Service Bulletin

PRELIMINARY INFORMATION

Subject: Steering Shudder (Vibration) During Slow Speed Maneuvers

Models: 2010-2013 Chevrolet Equinox
2010-2013 GMC Terrain
Equipped with Engine RPO LF1, LFW or LFX

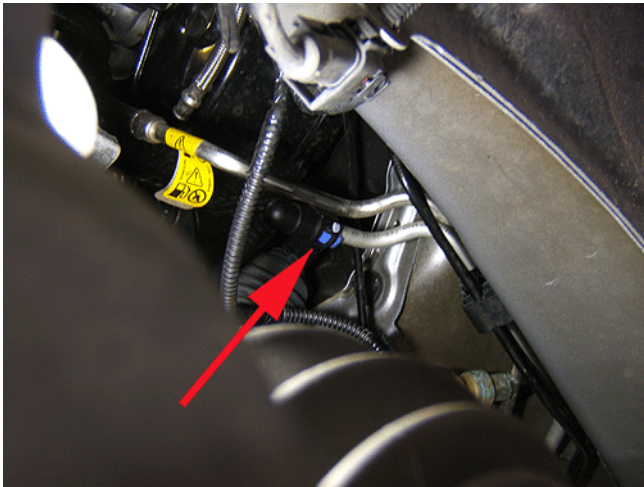
- 3.1. Disconnect the hose from the evaporative emission canister purge solenoid valve located by the base of the throttle body.

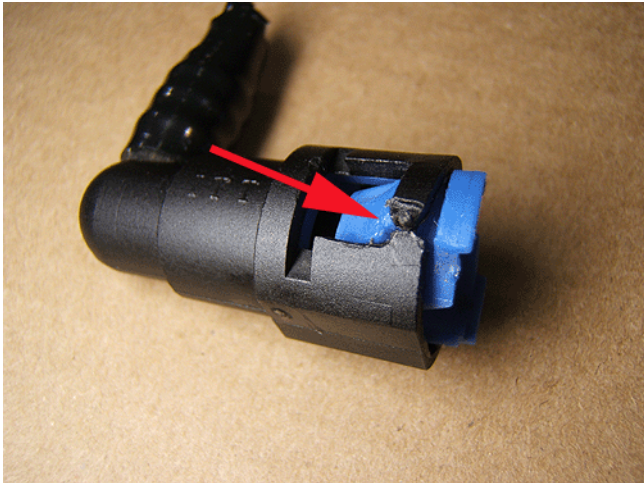
3.2. Disconnect the hose from the chassis to canister evaporative emission line.

It may be necessary to cut the plastic connector on the hose if the blue plastic retention collar cannot be released. A new connector is part of the new hose assembly.

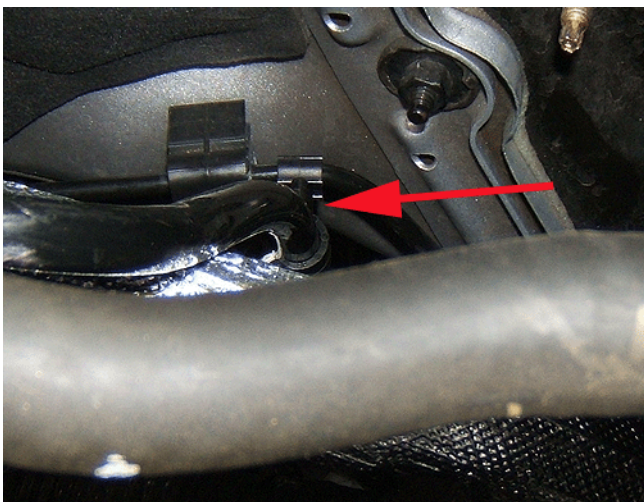
3.3. Remove the existing hose and install the new hose assembly.

Route the new hose in a way that avoids contact with chassis and body components. Connect both ends of the hose.

- 4.** Install the clip as shown, connecting the new evaporative emission canister purge hose assembly to the black metal cross car brake pipe.
- 5.** Inspect the new evaporative emission canister purge hose assembly and the revised power steering inlet hose to ensure no components are coming into contact with the new hose assemblies. If contact is present, loosen and reposition the new hose.
- 6.** Fill and bleed the power steering system. Verify the fluid level. Repeat the bleed procedure, if necessary. Refer to Power Steering System Bleeding in S
- 7.** Reinstall the intake manifold cover.
